INSTRUCTIONS FOR INCORPORATING REVISION III AMENDMENTS  
TO MODEL NP-50xxL APPLICATION, DATED JUNE 6, 1980

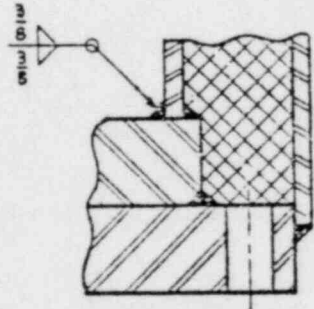
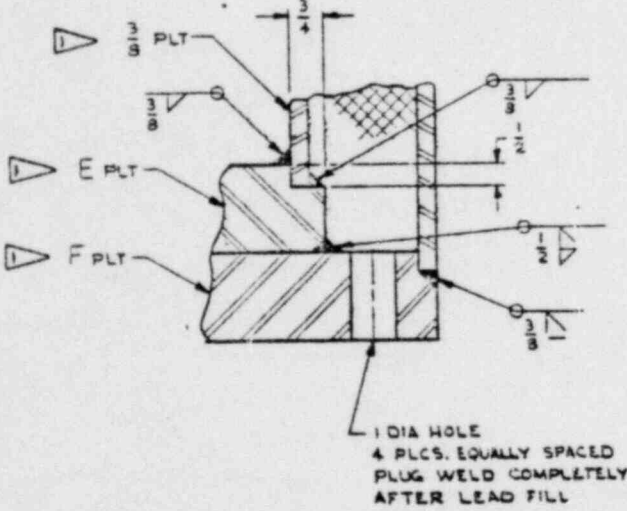
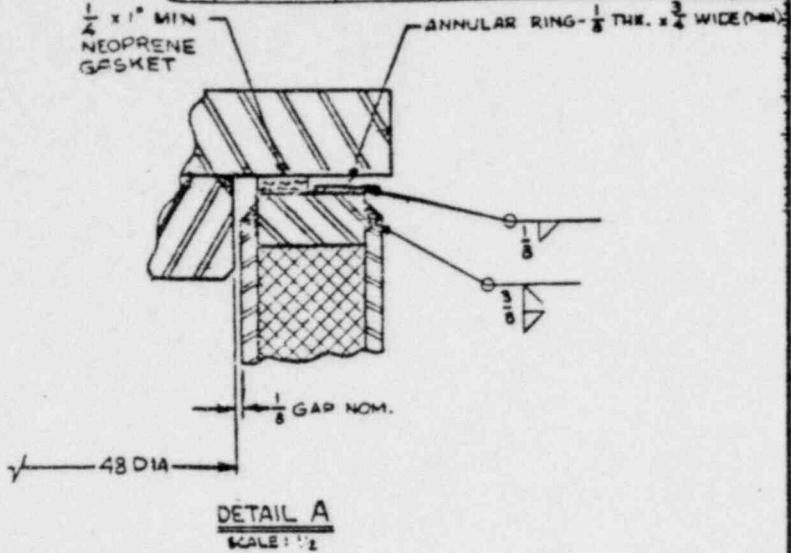
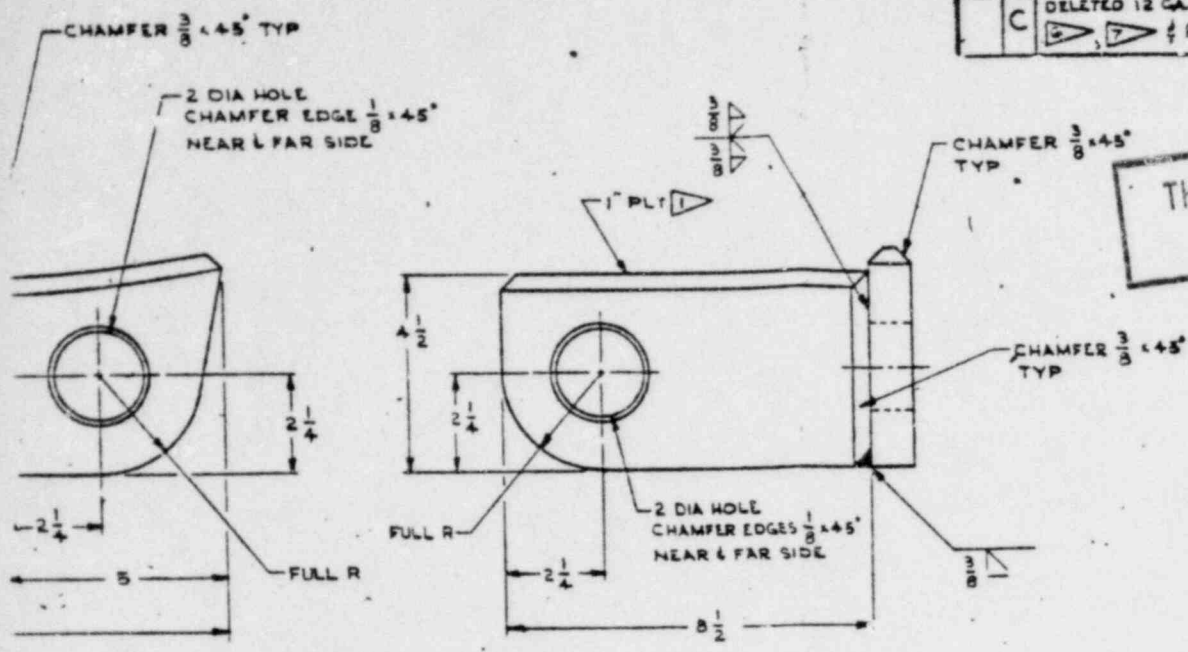
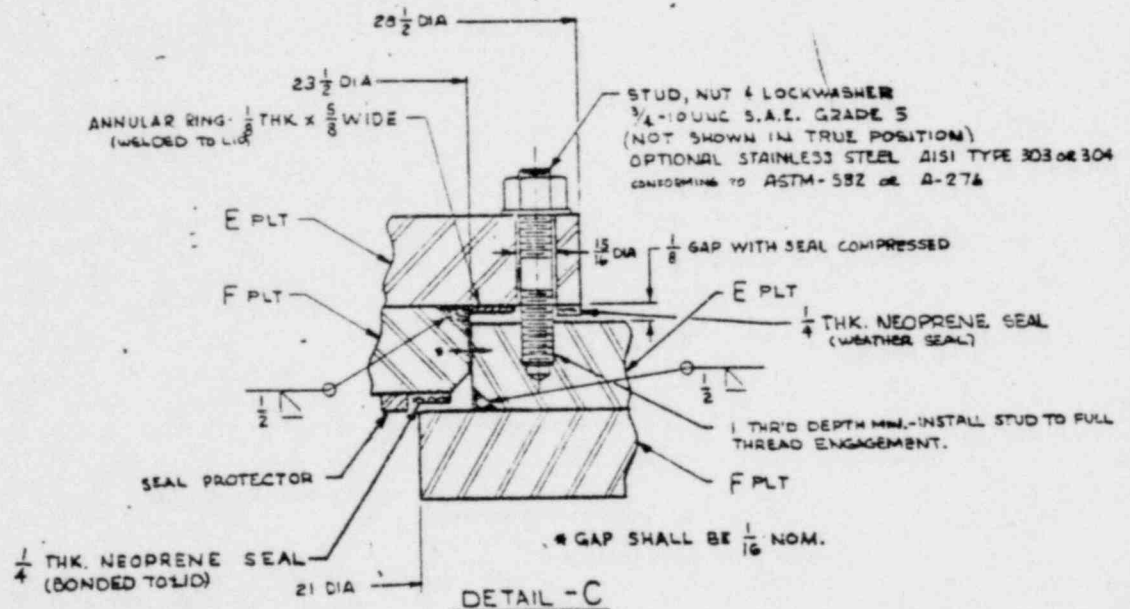
REVISED		DESCRIPTION	DATE	APPROVED
ZONE	LTN	REVISED TO DIMENSIONS, ORDER NO. 10401	16	<i>[Signature]</i>
A		ADDED GASKET CALOUT, REVISED OPT 2	16	
		DETAINA, REVISE MAT. DETAIL 2
